Renovation to Tierra Blanca  
615 Columbia Drive  
Hereford, Texas  
CHA# 1728

Bid Documents dated: 4/25/18

### **Addendum One**

1 SECTION AT WALL PANELS  
 $1 \frac{1}{2}" = 1'-0"$

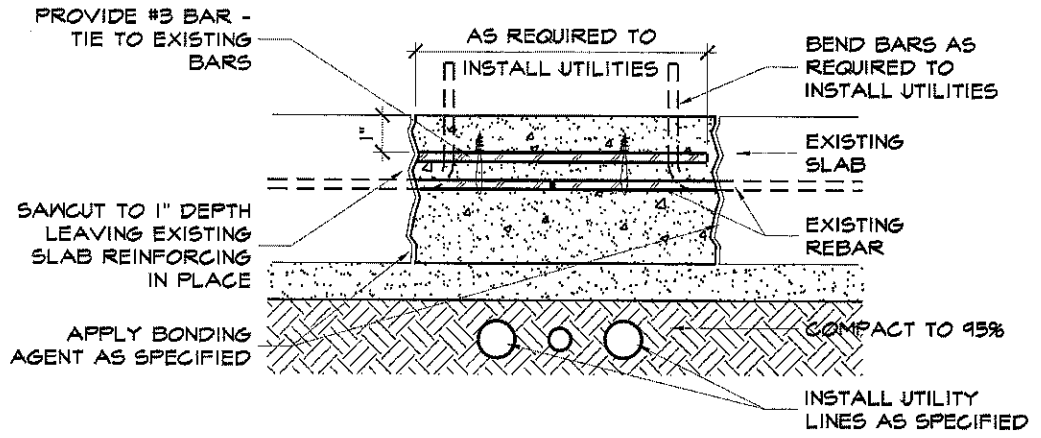
30. Sim detail labeled 12/A14 should read 2/A14.
31. See detail below for section at new panels on existing wall.

13. All PLAM doors to be factory glazed.
14. Refer to detail below for slab repair at new utility installation. It is contractors option whether to compact or provide flow fill at trench locations. Compaction shall be done in 6" lifts.
